METER

■COMBINATION METER

1. General

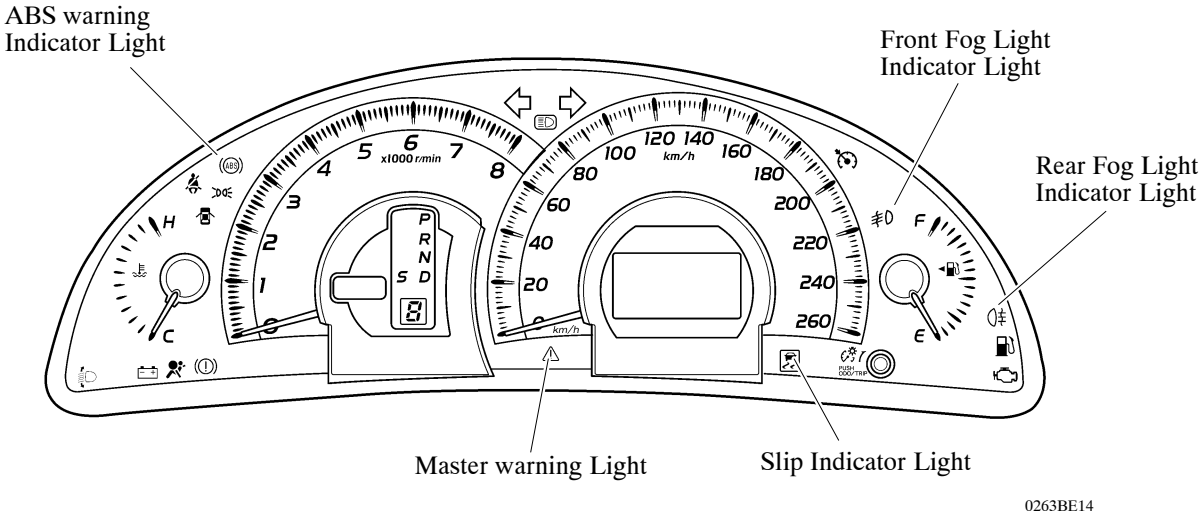
- The design of the combination meter has been changed.
- The positions of the ABS Warning Light, Front fog indicator Light, Rear fog indicator Light, and Slip indicator Light have been changed.
- The color of the Master Warning Light has been changed from red to orange.
